<u>Action Requested</u>: Special Exception to increase the allowed fence height of 8-feet inside a building setback (Sec. 45.080-A)

Location: 4845 S. 83rd AV E

BOA-23556

Zoning BLDC-150282-2023 (1)

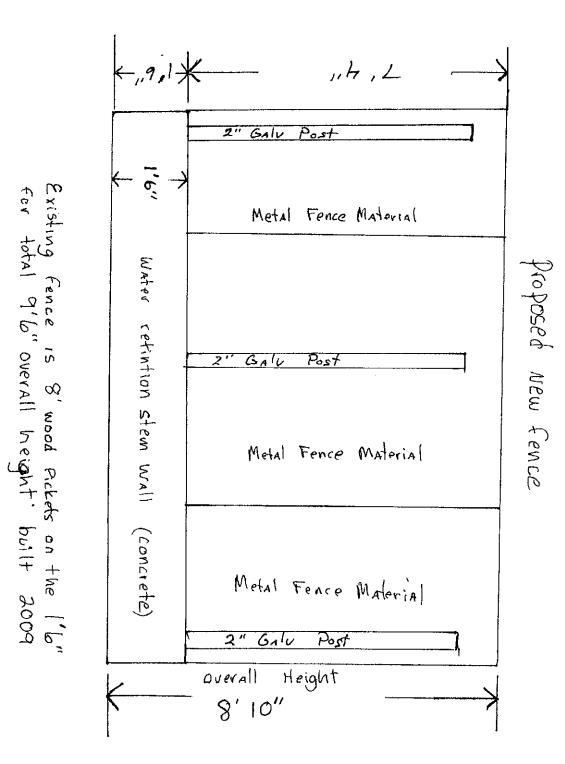
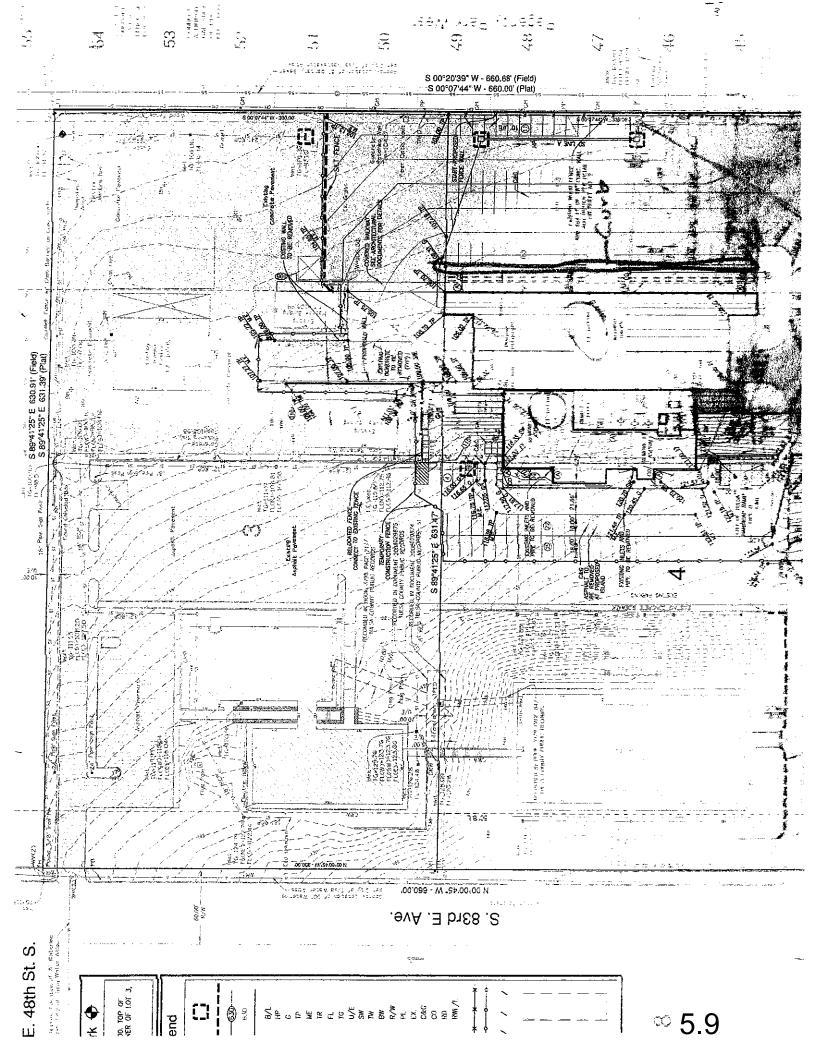
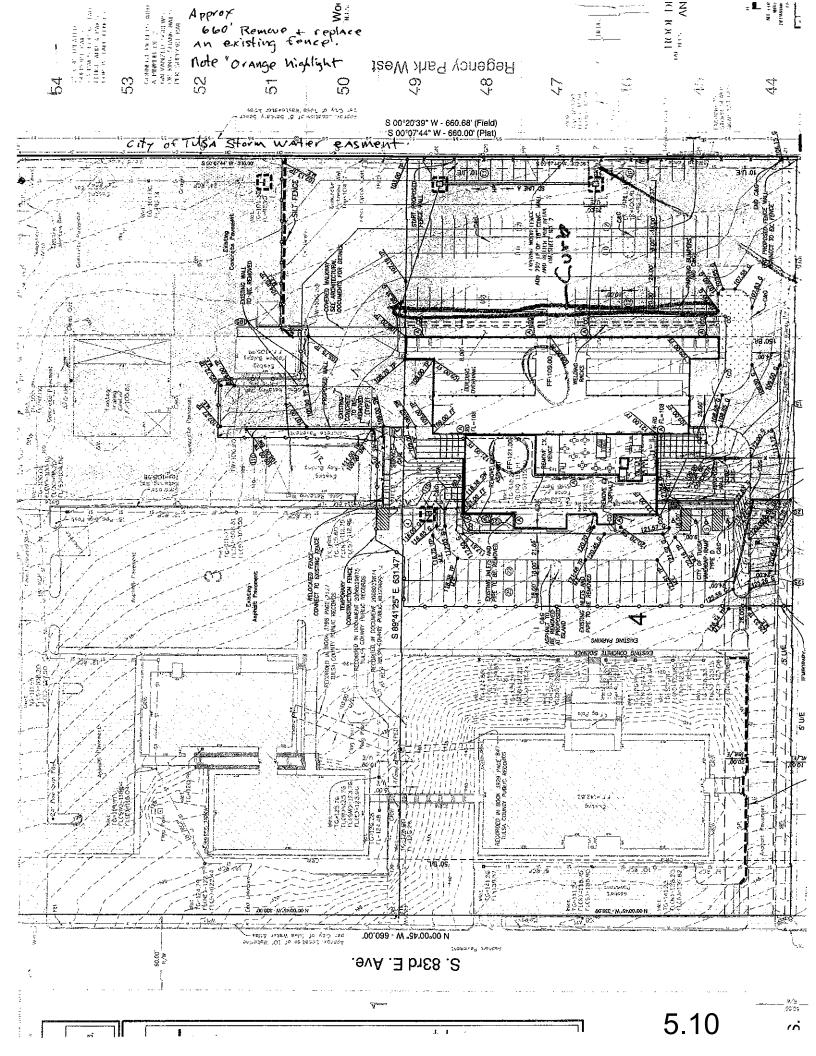
Section 45.080 Fences and Walls 45.080-A Fences and walls within required building setbacks may not exceed 8 feet in height, except that in required street setbacks fences and walls may not exceed 4 feet in height

Review Comment: Please provide total height on plans. Total height cannot exceed 8'.
